Project Amendments  
BLD2021-03082  
APN 037-333-200  
130 Bridgeport Dr.  
Half Moon Bay, CA 94019

## SUMMARY OF CHANGES

November 2, 2023

## 1 DAYLIGHT PLANE STUDY - ELVEVATIONS

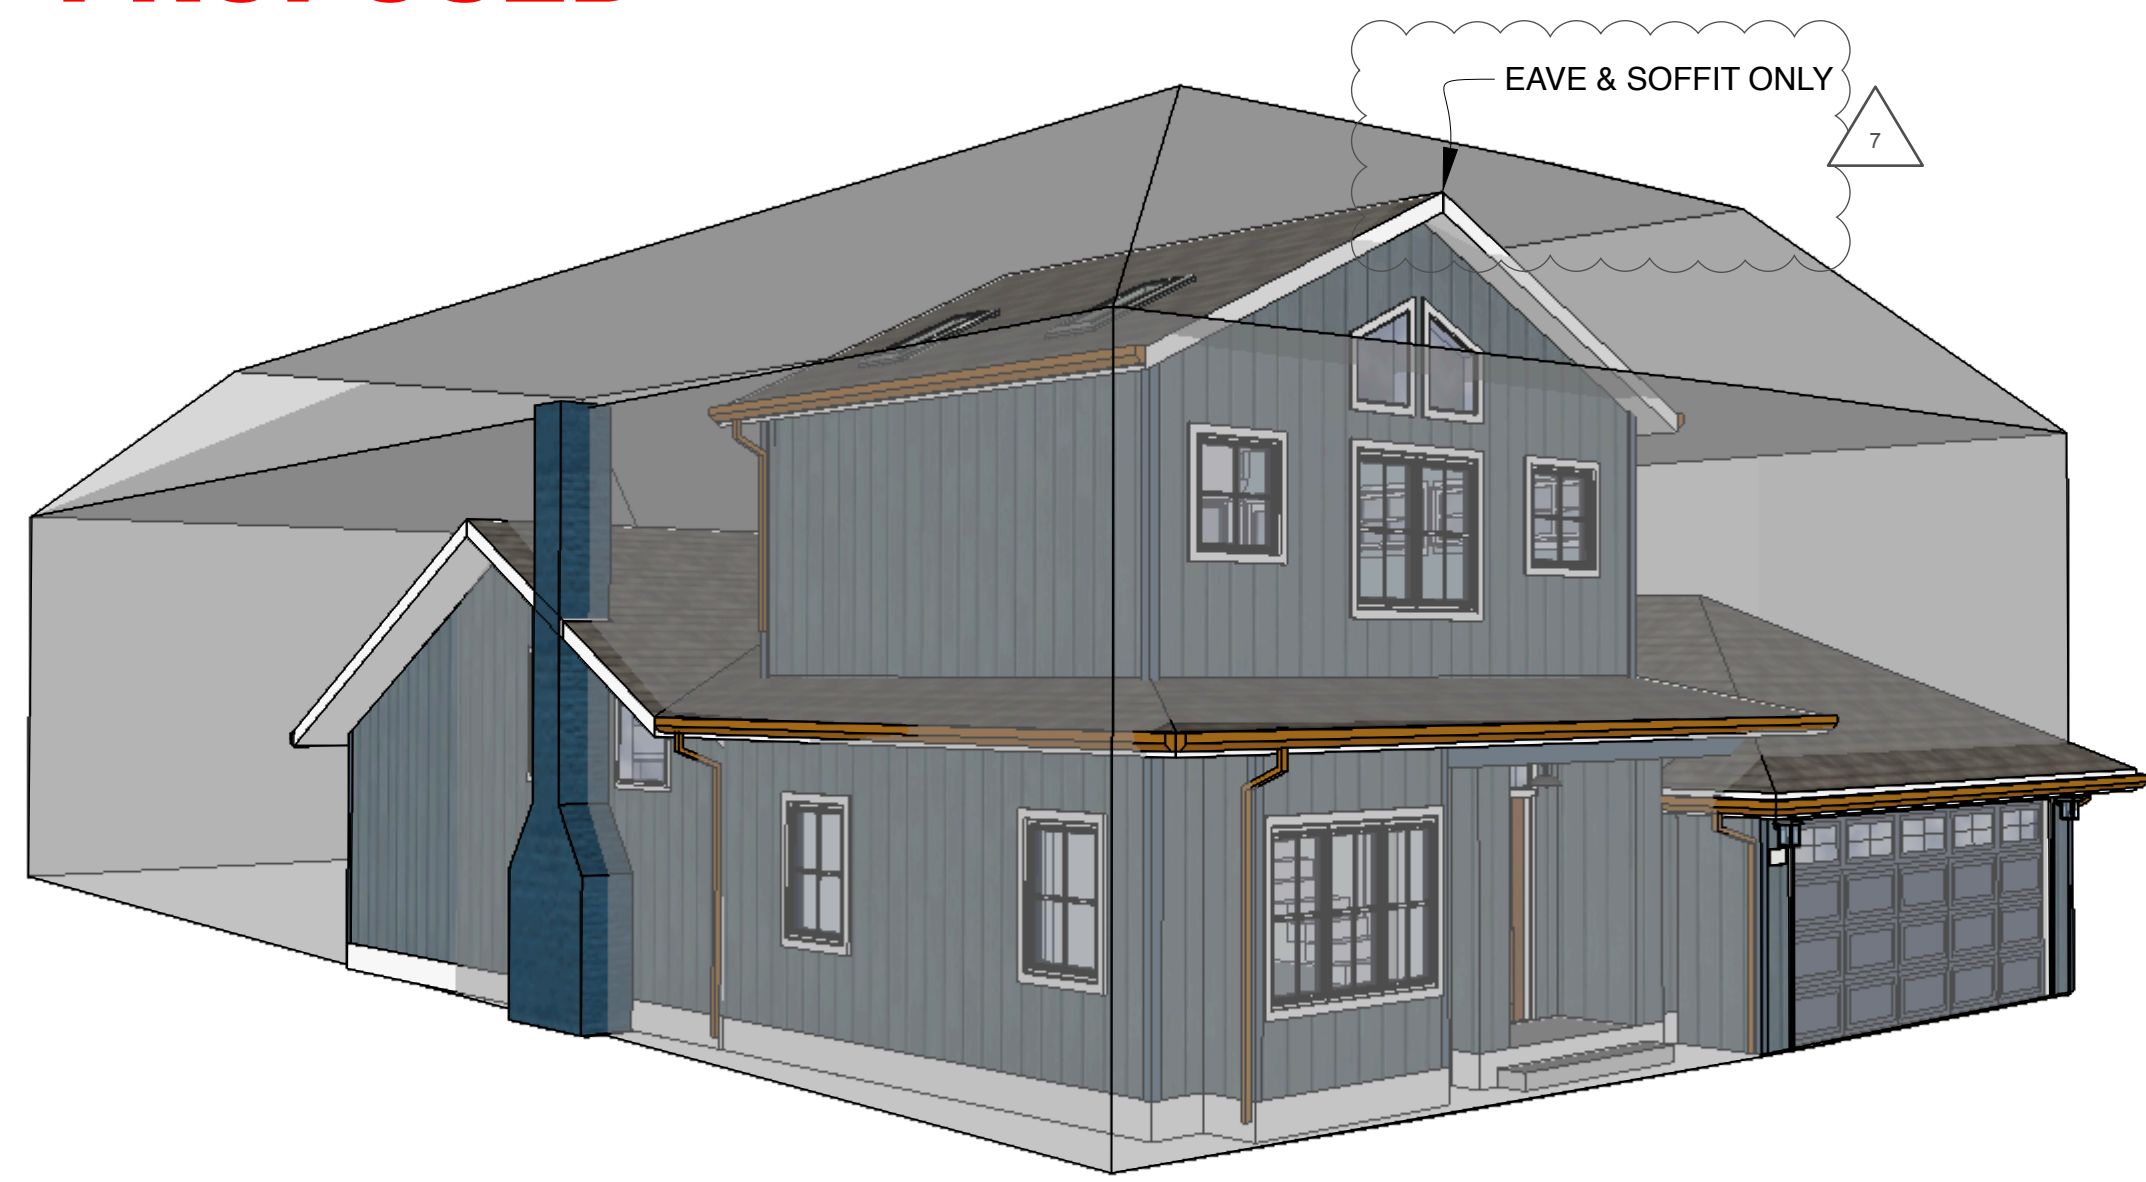
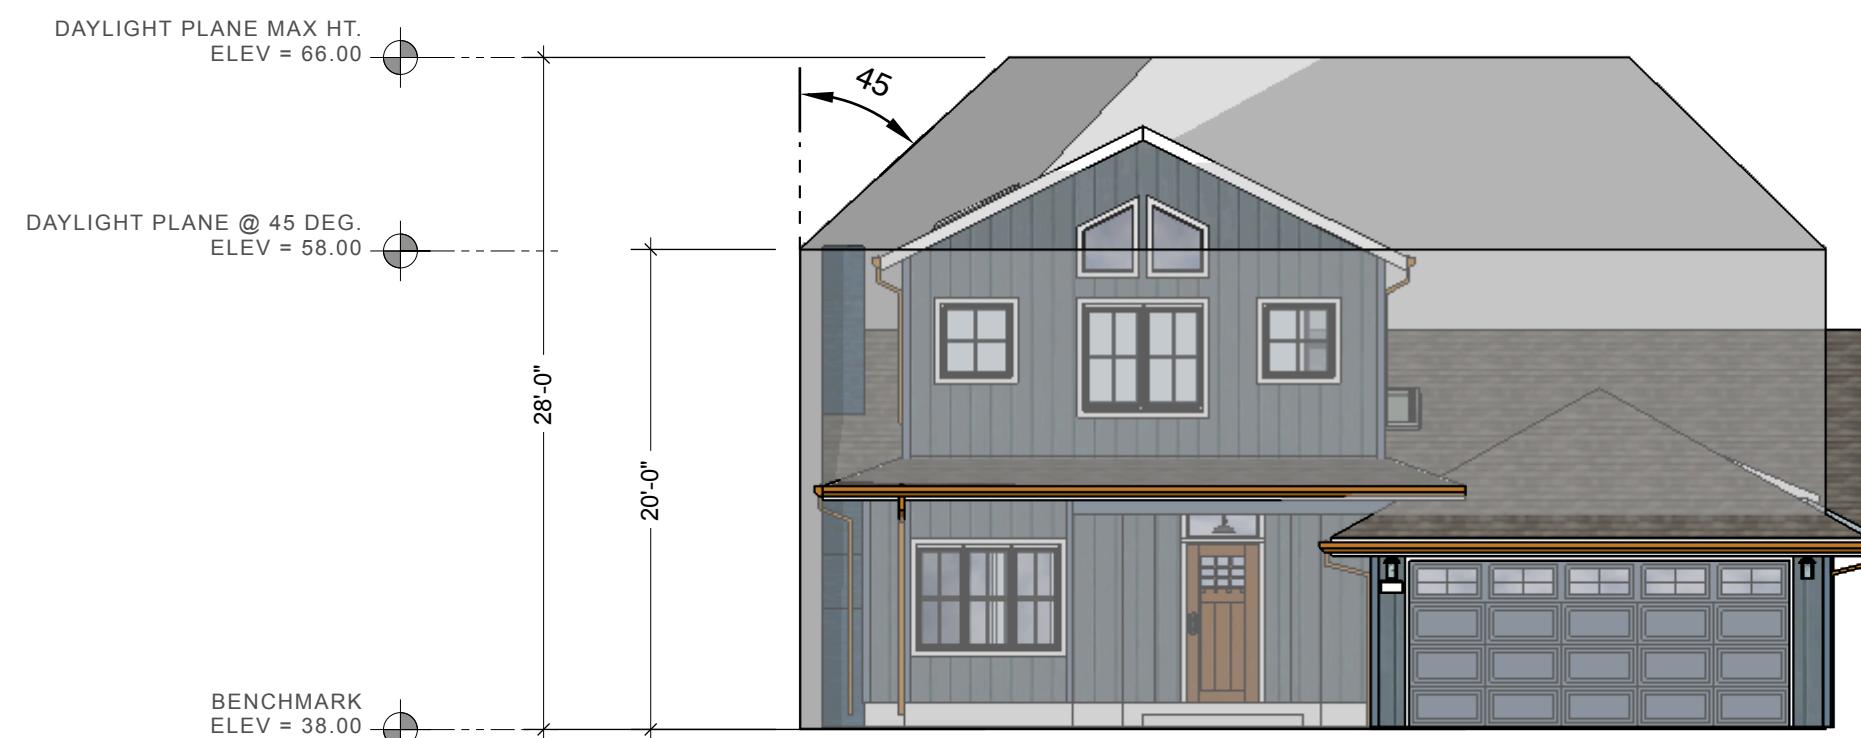
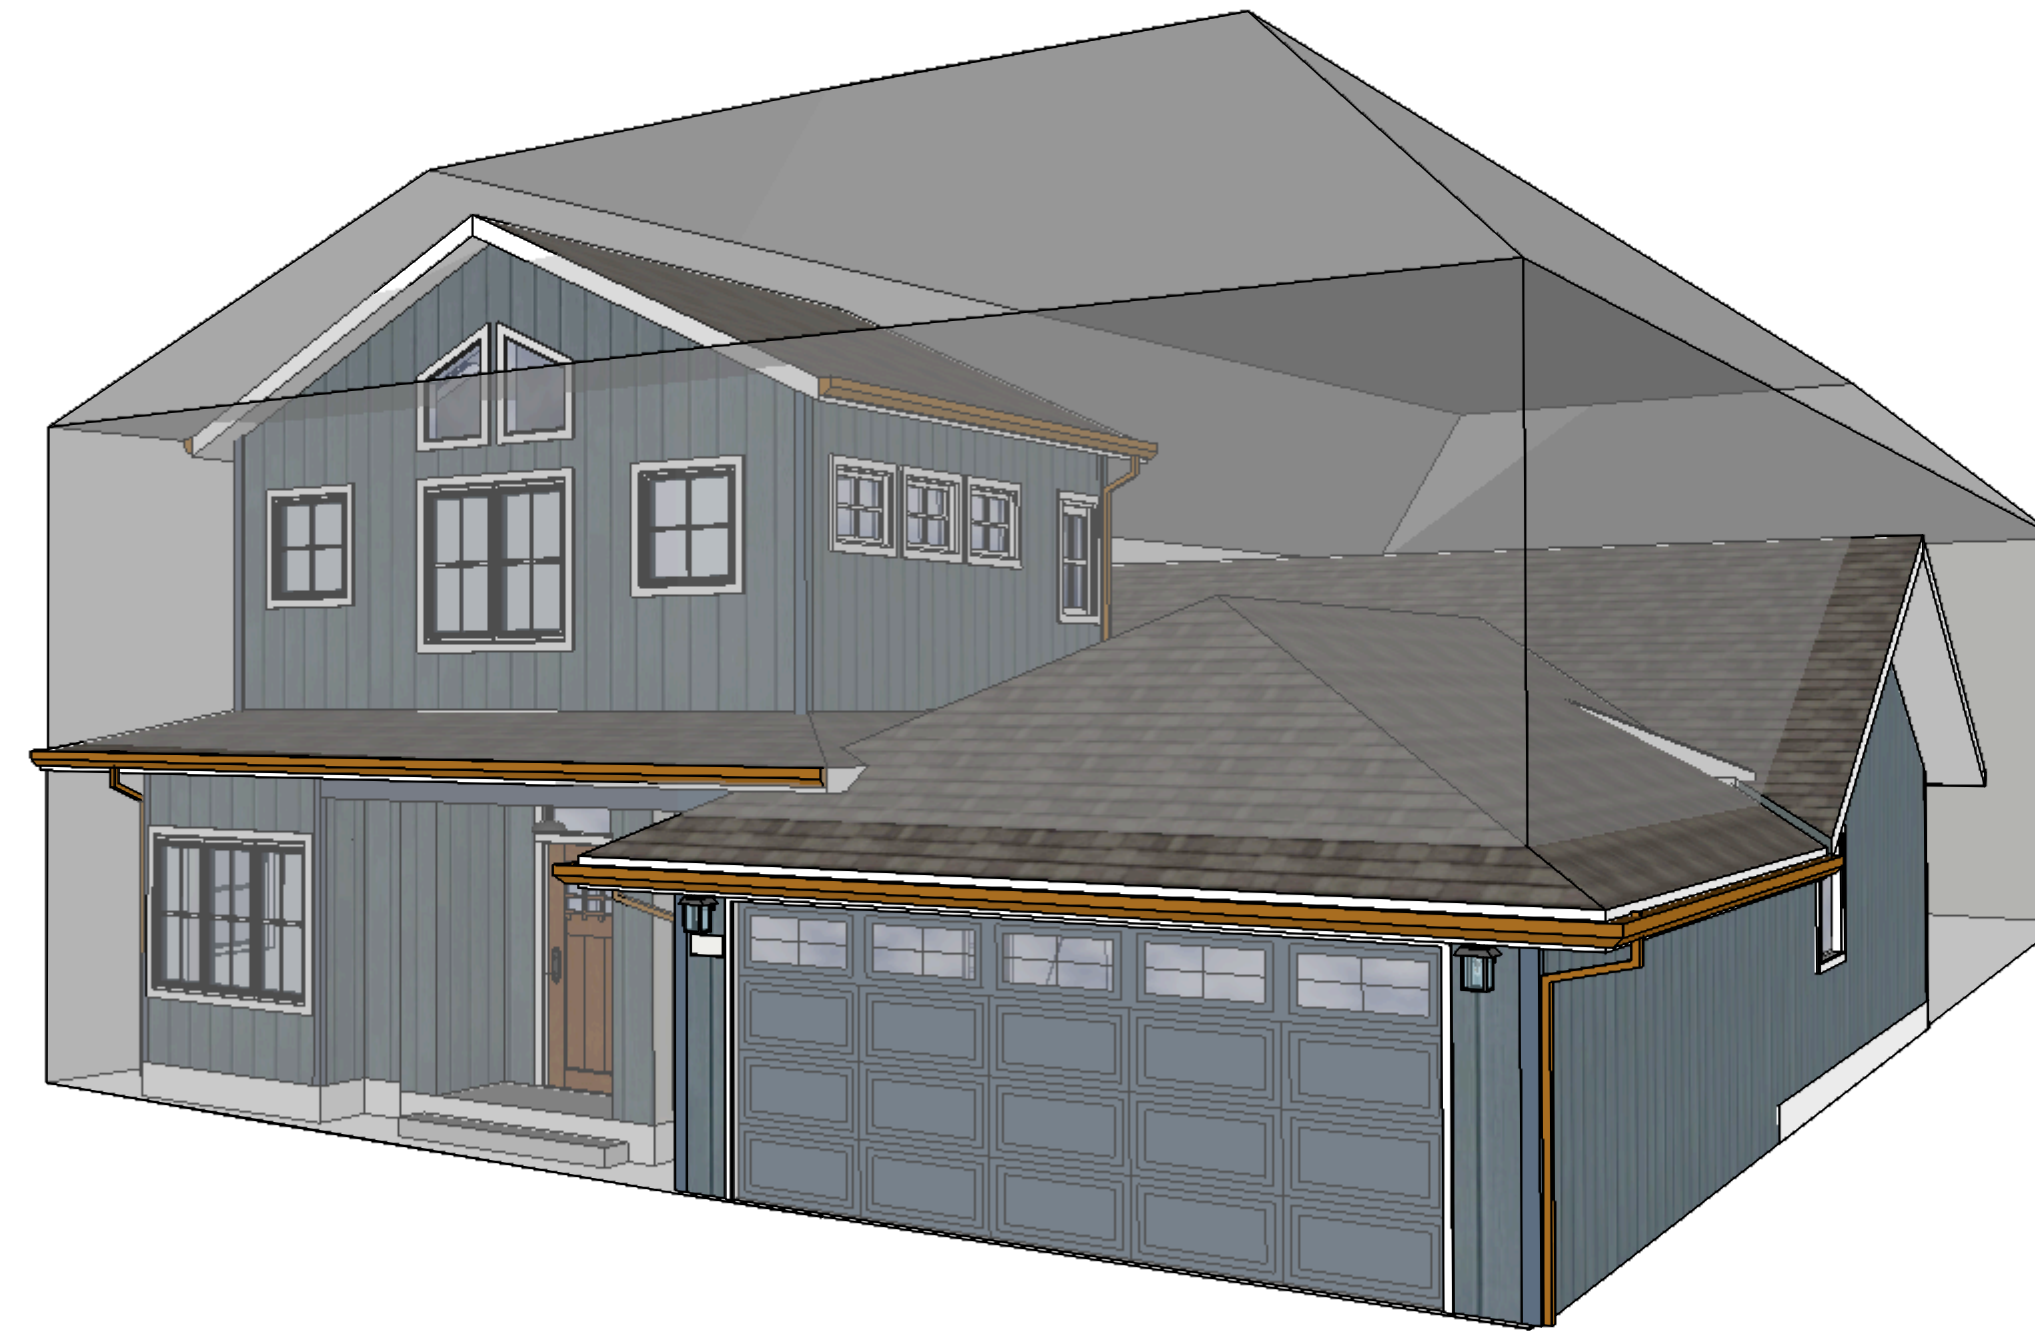
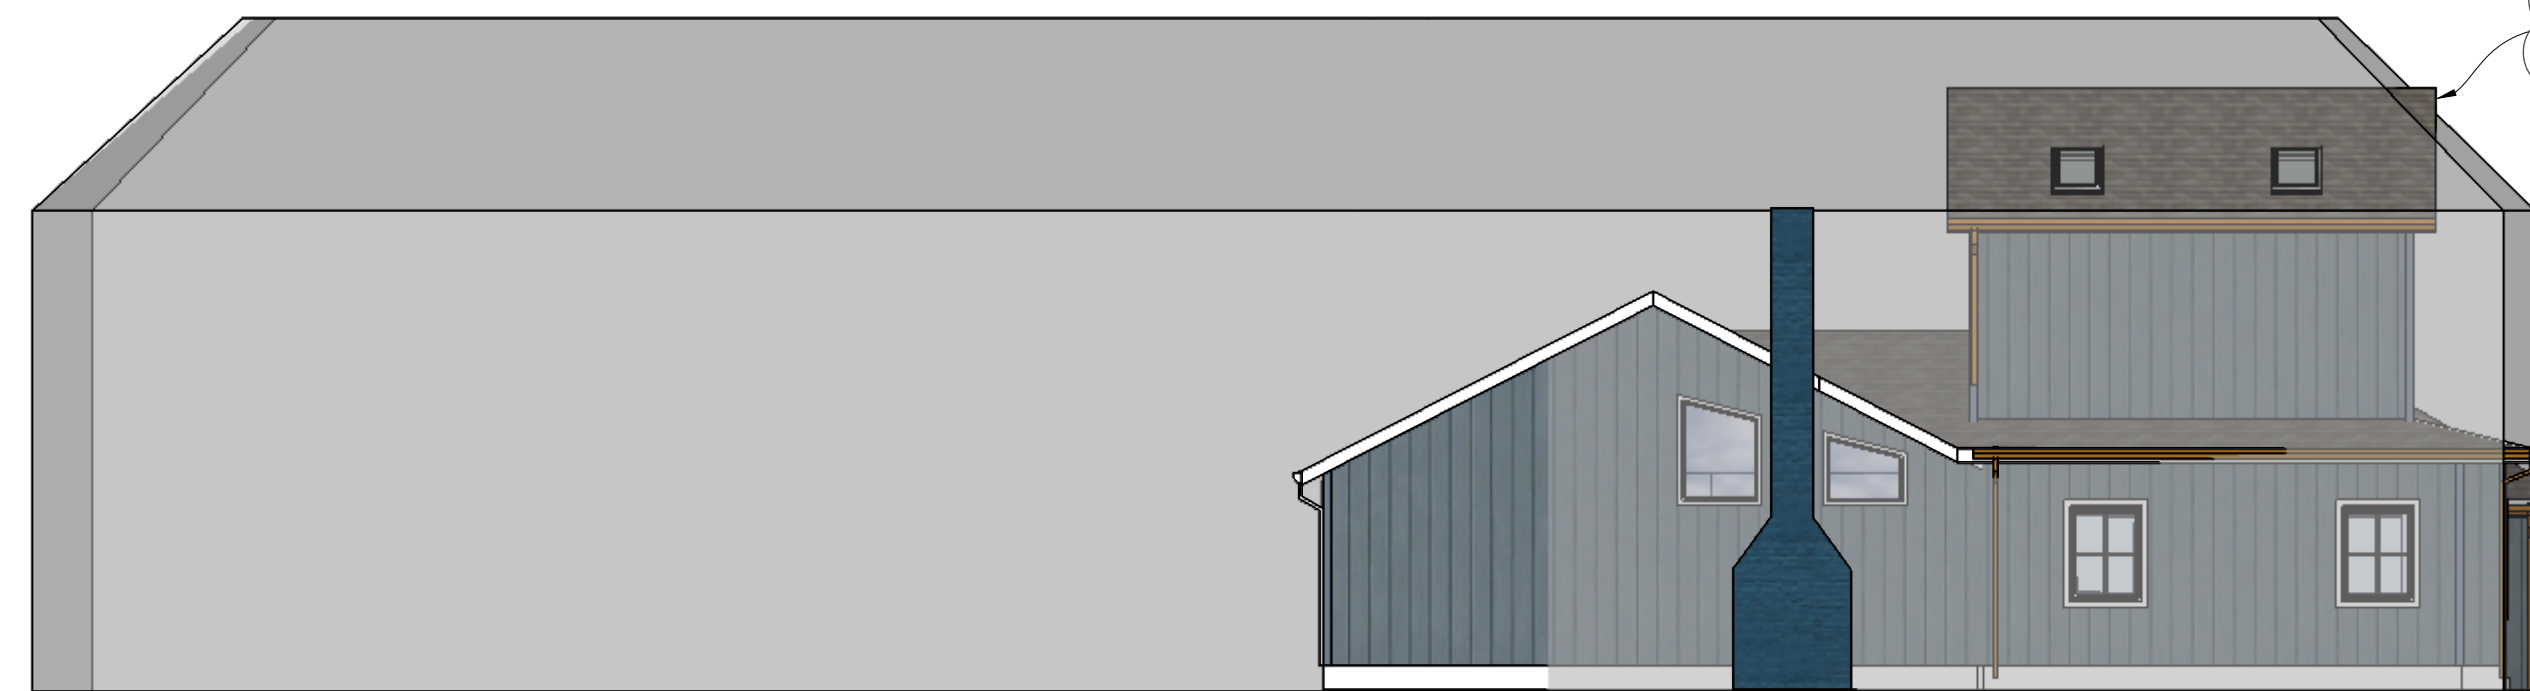
The first change proposed is the building height. The approved Ridge Elevation was 62.5 and the surveyed height is 63.3. The height of the structure is 25'4" and well within the height restrictions for zoning district R-1/S-17. The approved height was 24'1". This architectural change was made to match the drawings provided by the structural engineer. Details are noted in the Plans on pages G0.01 under Site Data, A3.01 Proposed Exterior Elevation – East and North, A3.02 Proposed Exterior Elevation – West and South, A6.01 Proposed Building Section, and A8.02 Daylight Plane Study – Elevations. Please note that the approved Daylight Plane Study showed the eaves of the front of the second story on the new addition extending 6" outside of the daylight plane (there are no changes to the first floor).
